# Access Compliance Report

## Public Rights-of-Way

### (Curb Ramps)

Intersection ID: 7329	Main Street: DAWNSHIRE_AV	Cross Street: NORTHCLIFF_DR	Location:	N
ADA ID: B8E8570EB687	Ramp Type: Perp	Initial Pass/Fail: Fail	Overall Compliance: No	Severity Score: 25

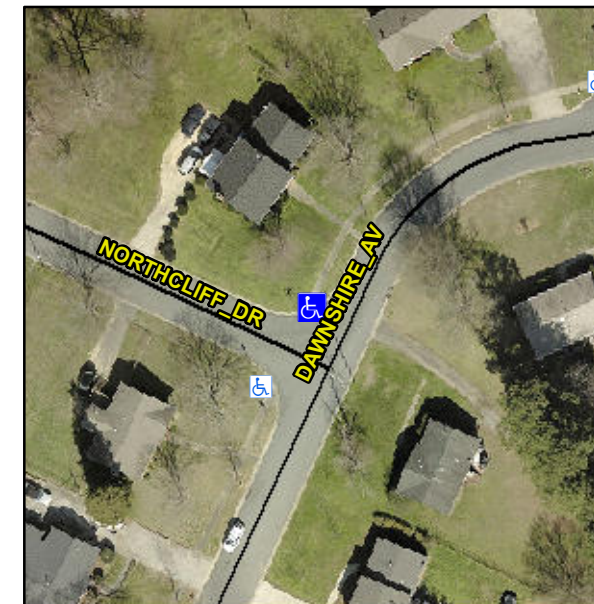
**Not Found, R304.5.3**

Compliance	Description	Data	Compliance	Description	Data
N/A	Ramp Length (in)	43.0	Yes	Ramp Slope (%)	8.2
Yes	Ramp Width (in)	48.0	No	Ramp XSlope (%)	7.1
N/A	Flare Type LT	N/A	N/A	Flare Type RT	N/A
N/A	Flare Slope LT (%)	N/A	N/A	Flare Slope RT (%)	N/A
N/A	Flare Traversable LT?	N/A	N/A	Flare Traversable RT?	N/A
N/A	Landing Length (in)	N/A	N/A	DWS Provided?	N/A
N/A	Landing Width (in)	N/A	N/A	DWS Contrast?	N/A
N/A	Landing Slope (%)	N/A	N/A	DWS Length (in)	N/A
N/A	Landing X Slope (%)	N/A	N/A	DWS Full Width?	N/A
N/A	Landing Curb? (Y/N)	N/A	N/A	DWS Offset (in)	N/A
N/A	Shared Landing?	N/A			
N/A	Gutter Ponding?	N/A	N/A	Gutter Slope (%)	N/A
N/A	Gutter Lip Ht (in)	N/A	N/A	Gutter X Slope (%)	N/A
N/A	Painted X Walk1?	No	N/A	Painted X Walk2?	N/A
	X Walk 1 Direction	To SW		X Walk 2 Direction	N/A
N/A	X Walk 1 Width (in)	N/A	N/A	X Walk 2 Width (in)	N/A
	X Walk 1 Slope (%)	2.0		X Walk 2 Slope (%)	N/A
	X Walk 1 X Slope (%)	8.5		X Walk 2 X Slope (%)	N/A

**Remove & Replace Entire Ramp.**
